RE: Columbine Motel Expansion, Request for TEDS exception for driveway spacing

#2 RE: Columbine Motel Expansion, Request for TEDS exception of Right-of-Way width

DESIGN EXCEPTION #DE23-03

RE: Request to Reduce Access Spacing and Right-of-way Width at 2824 North Avenue

COLUMBINE MOTEL
SITE PLAN

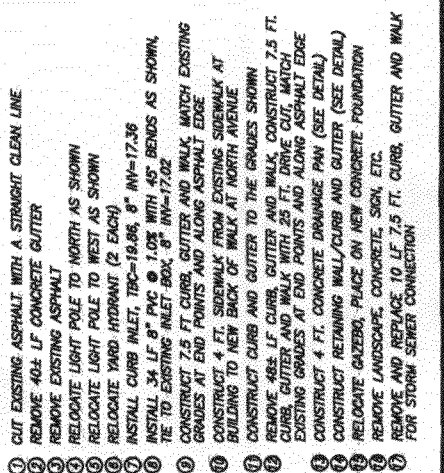
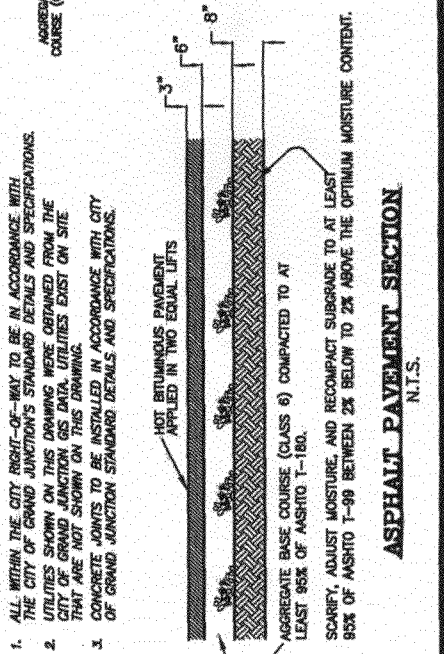
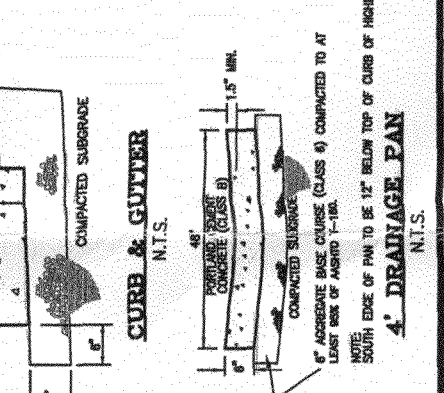
We propose that a new drive cut be located 11 feet north of the existing drive cut. This would result in an offset of 11 feet (as opposed to 22 feet) with the drive cut across the street. Three other drive cuts to the north will then be closer than 150 feet, located at 87 feet and 149 feet across the street and at 130 feet north on the same side of street. By decreasing the offset distance conditions will be improved as compared to existing configuration.

We propose to dedicate the 30 feet of Right-of-Way along 28 $\frac{1}{4}$ Road except for the 25.50 foot section where it would conflict with the existing building.

TEDS Exception 1: Driveway spacing. Applicant proposes to close existing entrance to North Avenue (Minor Arterial) and retain one access at approximately the current location on 28 ¼ (Urban Collector). Driveway cannot meet spacing requirements and intersection clearance requirements. Alignment with opposing driveway would eliminate parking in front of building. Recommend approval.

TEDS Exception 2: Right-of-Way Width. 28 ¼ Road is shown as an Urban Collector, The building (one story) is currently built to the back-of-walk. City has requested an additional 4.5' where the building exists to accommodate future right-of-way. Applicant proposes to not dedicate right-of-way where in conflict with the building AND build a second story on to the building in this location. Recommend denial.

The existing access along 28 ¼ Road is offset by only 22 feet from another existing drive along the east side of 28 ¼ Road. There are three other driveways farther north along 28 ¼ Road that are within 150 feet of the existing and proposed access. The proposed access will be 22-feet wide. It is proposed to be only 11 feet, center to center, south of the existing driveway to the east and about 30 feet from the north line of the applicant's property.

The requested 11-foot offset from the existing access across 28 ¼ Road should result in a significantly safer situation than what presently exists. Opposing left turns into these two drives would not be affected. The proposed location will be better than the original location and the worst access, onto North Avenue, is being eliminated. There does not appear to be any location on the lot that would fully comply with TEDS.

Reducing the right-of-way to allow vertical expansion of the existing building will maintain an impaired site distance to the north and significantly reduce the future ability to use this street as an Urban Collect. These limitations will significantly compromise safety for travelers along 28 ¼ Road and for people trying to exit this parking lot.

Please find attached the committee's decision on the above request. The Review Committee approved your request for reduced access spacing along 28 ¼ Road. However, your request for a reduction in the width of the right-of-way for this street was denied. I would suggest that you initiate a request for a revocable permit to allow the existing building to remain in the right-of-way and adjust your plans for any improvements above the portion of the building within the proposed future right-of-way.

I recommend approval of the requested Design Exceptions to Sections 4.1.1 and Section 4.1.2 to allow the new parking lot access from 28 1/4 Road as long as it is designed to meet all other requirements of the TEDS.

I recommend denial of the request to reduce the right-of-way along the portion of 28 1/4 Road where the existing building sets. The applicant should be guided to the Revocable Permit process to receive consideration for the existing building to remain in the right-of-way to be dedicated.
